Big Rivers Electric Corporation Disposal of Coal Combustion Residuals (CCR) from Electric Utilities Final Rule CCR Landfill Annual Inspection Report

Name: Green Station CCR Landfill

BREC Final Rule CCR Landfill Annual Inspection Checklist

Noted Deficiencies

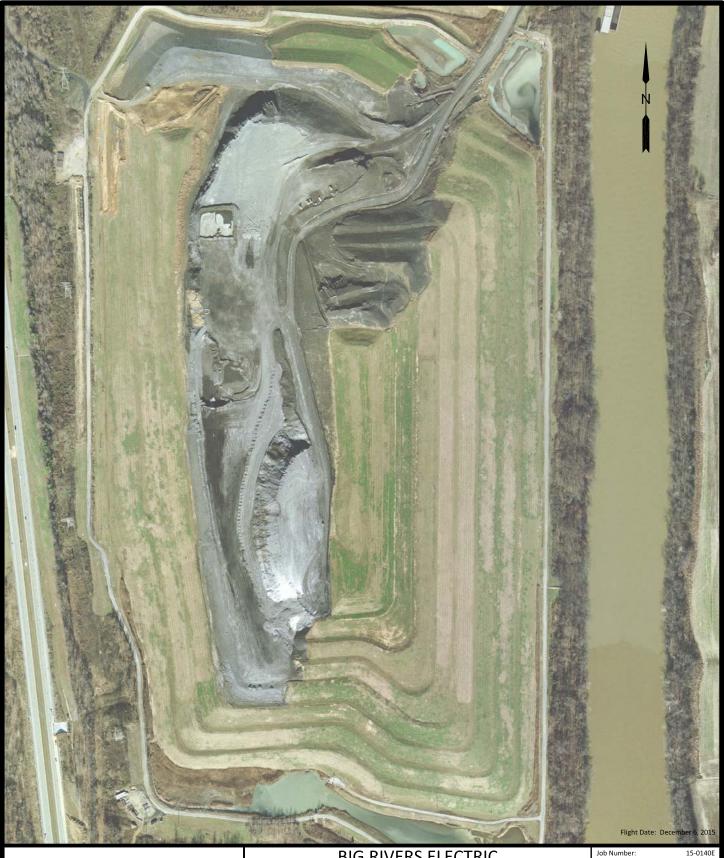
1. Storm water catch basin grades and/or soil settlement around catch basin inlets and flowline obstructions/uneven drainage grades on benches are allowing infiltration to occur instead of proper conveyance of storm water runoff from the pile.

- 1. A contractor has been retained to make necessary storm water catch basin inlet repairs.
- Associated Engineers, Inc. will be retained to assist in developing measures to address, as soon as practicable, storm water catch basin grades and flowline obstructions/uneven drainage grades on benches that are allowing infiltration to occur instead of proper conveyance of storm water runoff from the pile.
